Entergy Nuclear Operations, Inc.
Palisades Nuclear Plant
27780 Blue Star Memorial Highway
Covert, MI 49043-9530
Tel 269 764 2000

PNP 2014-029

SUBJECT: Response to Third Request for Additional Information dated March 5, 2014, for Relief Request Number RR 4-18 – Proposed Alternative, Use of Alternate ASME Code Case N-770-1 Baseline Examination

Palisades Nuclear Plant
Docket 50-255
License No. DPR-20

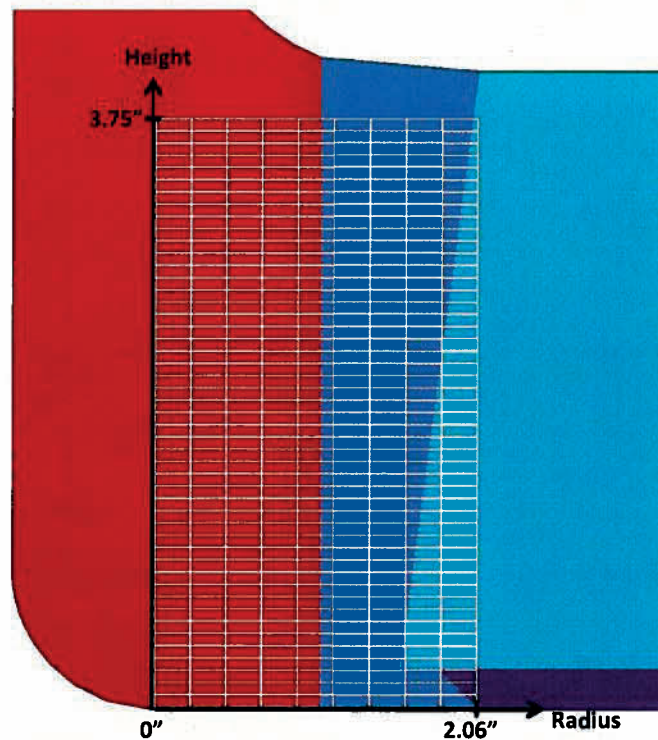
Provide the thickness of the alloy 182/82 cladding on the inside surface of the welds. For the hot leg weld, confirm that the 21-inch inner pipe radius is from the inside surface of the alloy 182/82 cladding.

The thickness of the alloy 182/82 cladding on the inside surface of the weld is 1/4 inch nominal thickness with a minimum thickness of 5/32 inch. The inner radius at the hot leg drain is 21.34 inches measured from the inside surface of the cladding to the centerline of the hot leg pipe.

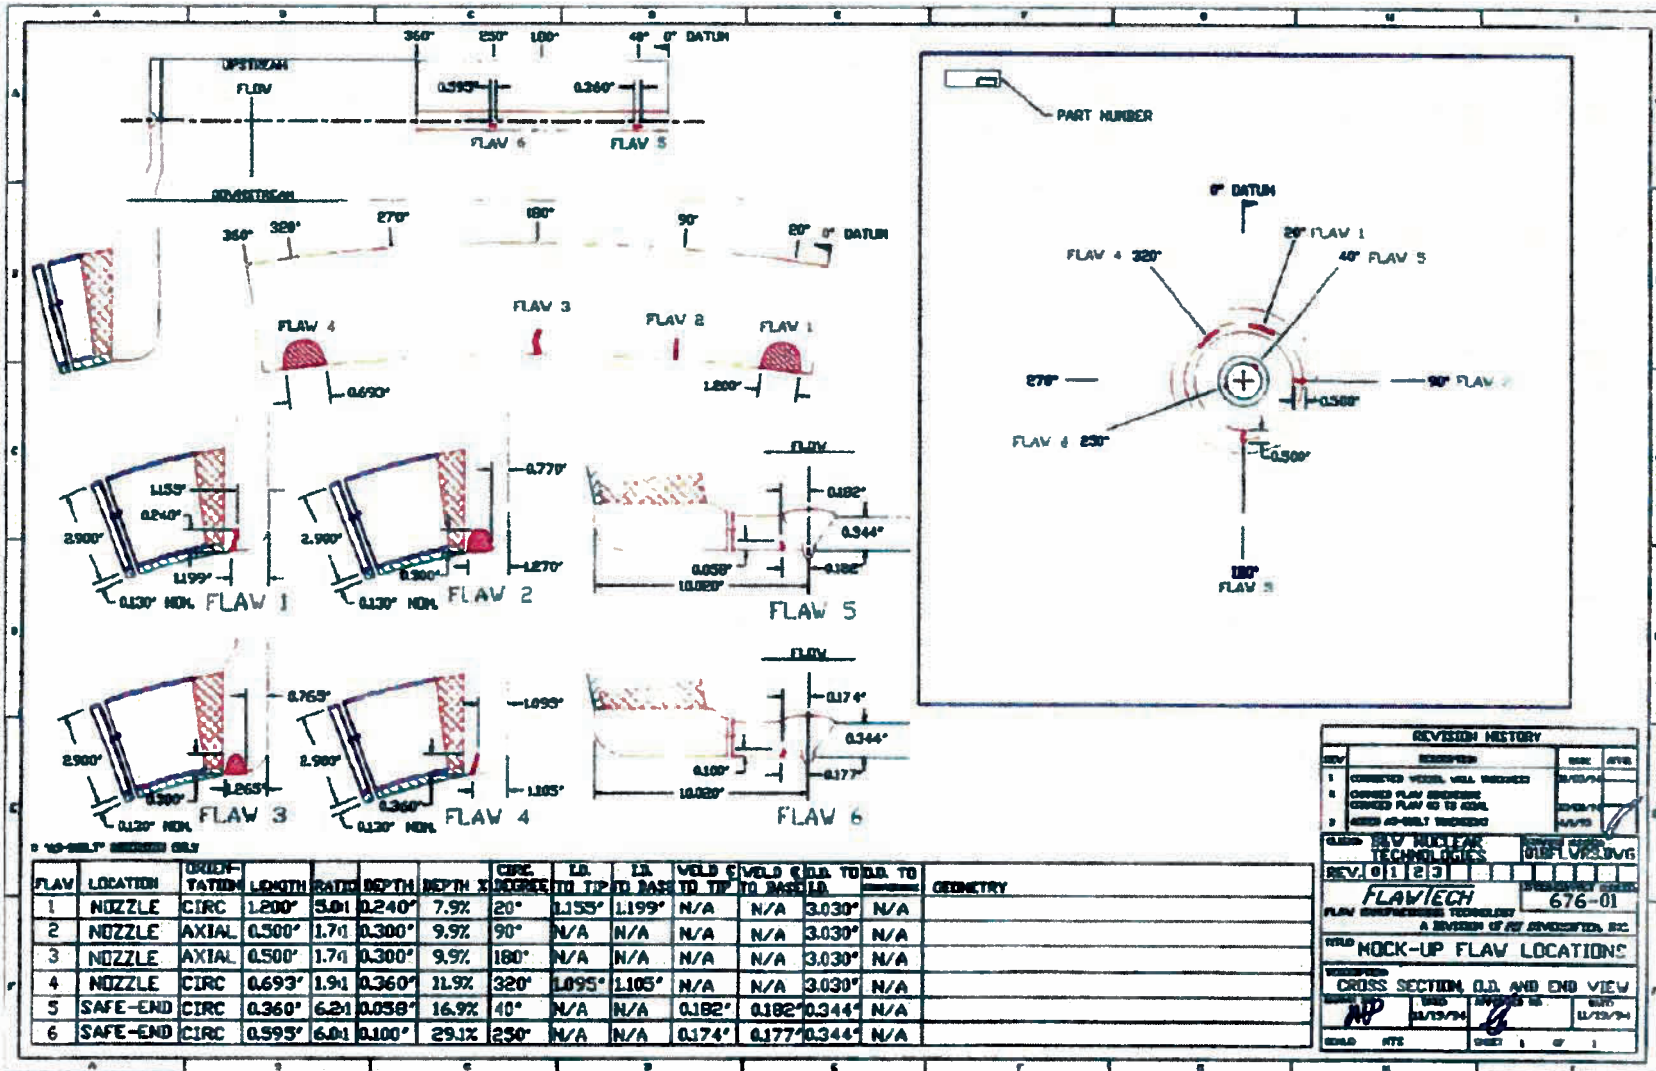
Given the licensee's statement, "the mockup was used in conjunction with a current PDI-qualified manual phased array procedure, equipment, and personnel to determine if a qualified examination on this complex configuration could be produced. During the testing, known flaws within the mockup specimen could not be reliably detected," describe the site-specific mockup used to test the ultrasonic inspection procedures. Include general size of the mockup, materials, and the following in the response.

- A. Provide the flaw types and sizes in the site specific mockup.*
- B. What flaws were detected with the manual phased array ultrasonic inspection technique?*
- C. What flaws were not detected?*
- D. What angles were scanned in performance of this demonstration?*

In what way does the site specific mockup not meet the requirements of "Site Specific Configuration Mockup Requirements for Dissimilar Metal Welds," Revision C" (e.g. geometry, flaw types, materials, etc.)

Palisades' site-specific mockup general size (dimensions) and materials are shown in Attachment 2, "Palisades Site Specific Mockup Drawings Specimen 676-01."

- A. The Mock-Up Specimen 676-01 contains a total of six flaws, four flaws in the nozzle base material and two flaws in a 2 inch pipe weld. Flaw #1's orientation is in the circumferential (CIRC) direction with a length of 1.200 inch and a depth of 0.240 inch, which represents a 7.9% through wall crack from the inside diameter (ID) surface. Flaw #2's orientation is in the AXIAL direction with a length of 0.500 inch and a depth of 0.300 inch, which represents a 9.9% through wall crack from the ID surface. Flaw #3's orientation is in the AXIAL direction with a length of 0.500 inch and a depth of 0.300 inch, which represents a 9.9% through wall crack from the ID surface. Flaw #4's orientation is in the CIRC direction with a length of 0.693 inch and a depth of 0.360 representing a 11.9% through wall crack from the ID surface.

- B. All four flaws were detected with the aid of the mock-up design drawing. The drawing was used to locate the flaw locations prior to detecting them on the UT scan. Without this previous knowledge, the ability to detect the flaws using this method is questionable. This is attributed to the complex geometric configuration which causes numerous ultrasonic reflectors due to the weld joint configuration.

- C. All four flaws were detected with the aid of the mock-up design drawing.
- D. The performance demonstration conducted on the mock-up utilized the techniques listed in EPRI-DMW-PA-1, revision 4, "Procedure for Manual Phased Array (UT) of Dissimilar Metal Welds," paragraph 6.7.1, for longitudinal wave exams. The angles

scanned were for the qualified range of angles 25° thru 70°, with a one degree resolution.

The PNP mockup was designed prior to the development of the current industry "Site Specific Configuration Mockup Requirements for Dissimilar Metal Welds, Revision C." The mockup flaw sizes, flaw type, and flaw location do not conform to the current industry requirements. See attached PNP mockup design drawing and industry mockup requirements referenced in Electric Power Research Institute (EPRI) Report 3002000204, "Nondestructive Evaluation: Performance Demonstration Initiative (PDI) Guidance for Improved Reliability in Ultrasonic Examinations, Guideline for Hands-on Practice, PDI-GL-001, Revision B, Site Specific Mockup Requirements for Dissimilar Metal Welds, Revision C, Appendix A – Performance Demonstration Initiative (PDI), Site Specific Configuration Mockup Requirements For Dissimilar Metal Welds, Revision C," dated May 2013.
